2022/3694/P & 2022/4547/L

12 & 13 ('The Lodge') Primrose Hill Studios

Photos and Drawings – 12 and 13 ('The Lodge') Primrose Hill Studios

Delegated Report (Members' Briefing)		Analysis sheet		Expiry Date:	i) 25/12/2022 ii) 25/12/2022
		N/A / attached		Consultation Expiry Date:	i) 14/07/2024 ii) 14/07/2024
Officer				Application Number(s)	
Sam FitzPatrick				i) 2022/3694/P ii) 2022/4547/L	
Application Address				Drawing Numbers	
12 & 13 ('The Lodge') Primrose Hill Studios Fitzroy Road London NW1 8TR				Please refer to decision notice.	
PO 3/4	Area Team Signature	C&UD	Authorised Officer Signature		
Proposal(s)

6. Demolition (left) and proposed (right) floor plans of ground floor.

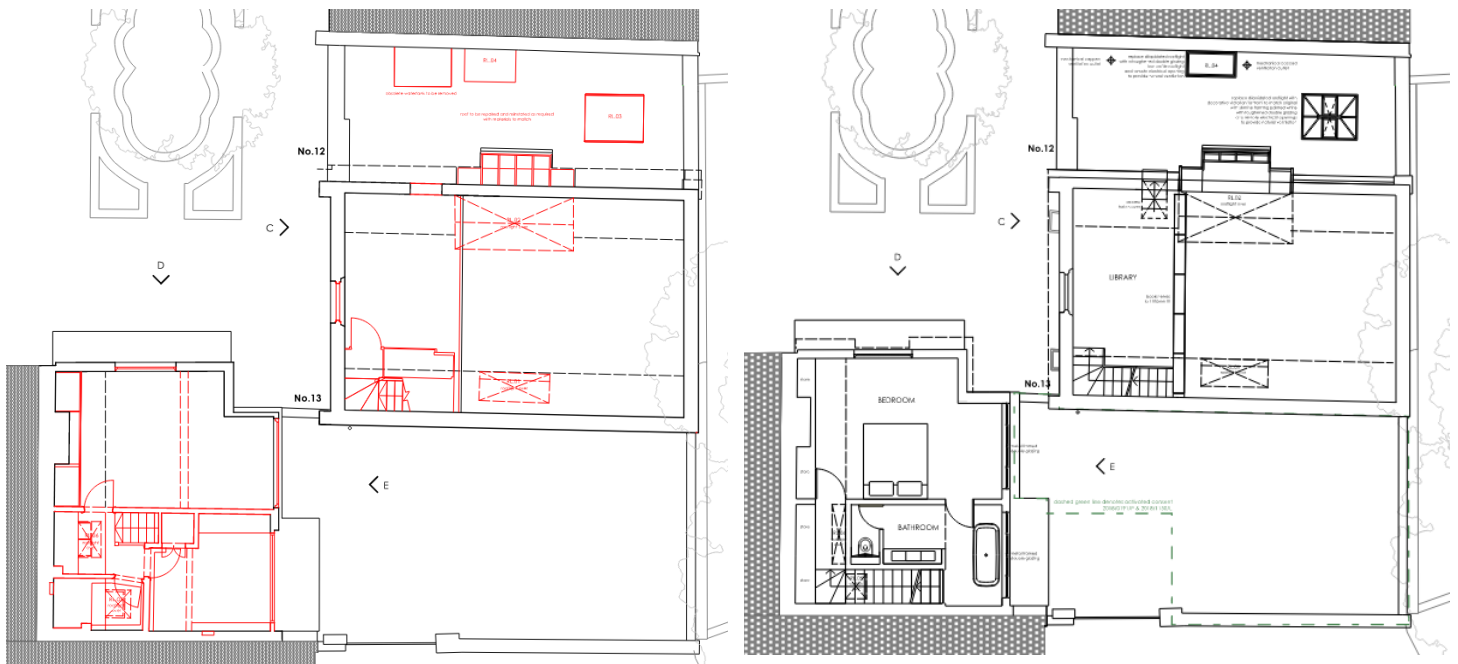
4.7. Internally, there would be minor changes to no.12; a new kitchen would be provided in the main studio area of the building, the non-original mezzanine staircase and balustrading would be removed and replaced, and the ancillary rooms would remain subdivided and separate from each other (not open-plan, as originally proposed). The removal of non-original features would be acceptable, and the new additions would not undermine the significance of the building. It should be noted that the kitchen units would not include high-level wall cupboards or an overhead extraction unit, which allows the gable wall of the main room to remain clear. There would also be works to the floor and ceiling, including to repair and retain the original pine boards and lath-and-plaster build up, respectively. Further details of the internal works would be secured by condition, especially with regards to the impact on historic fabric from the installation of new features, such as the access hatch. All these internal alterations are considered acceptable and do not impact detrimentally upon the internal appearance or spatial quality of the listed building, as well as maintain plan form.

4.8. To 'The Lodge', there are more significant internal alterations that primarily involve the relocation of the staircase from the centre of the building to the edge, and the associated layout changes that this entails. The domestic character of 'The Lodge' (arising from its historic use as a porter's lodge) is maintained by these alterations, and the 'two-up-two-down' character is retained, with the appropriate plan form kept. It should also be noted that the building has suffered extensive bomb damage during the second World War, so much of the significance has already been harmed, however the character can still be maintained, which the proposal now does. As with no.12, further details of the internal works would be secured by condition. The internal works to this building are therefore also acceptable and would not harm the significance of the listed buildings.

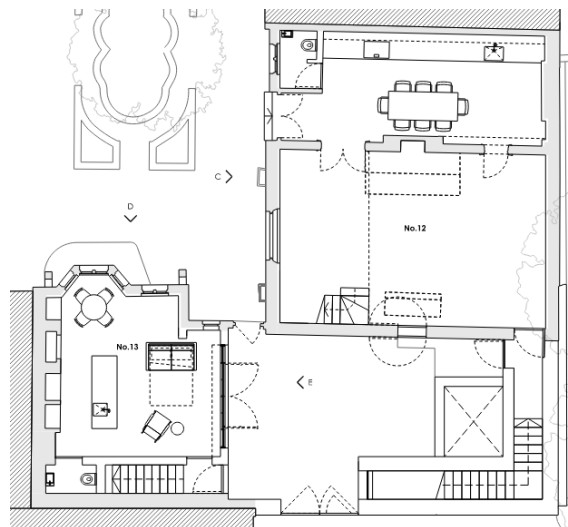
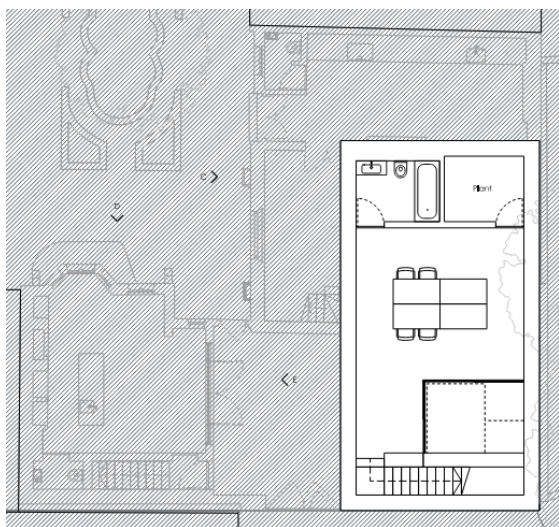
2.2. The original application included a sizeable basement that would be sited under part of no.12 and part of the courtyard, with a rooflight providing the basement with light. Above, a courtyard access would allow the basement to be accessed both from the courtyard itself and from the ground floor of no.12. The proposed basement (left) and ground floor (right) plans of the previous application are shown below.

2.4. A large amount of the original application would be unacceptable, and the Council was not able to support, which was communicated to the applicant. Following these officer comments and extensive discussions with the Council, the applicant provided revised plans that removed the basement from the proposal, as well as made amendments to the proposed internal alterations and removed the ASHPs proposed to the roof. These revisions have been accepted and are assessed as part of this recommendation.
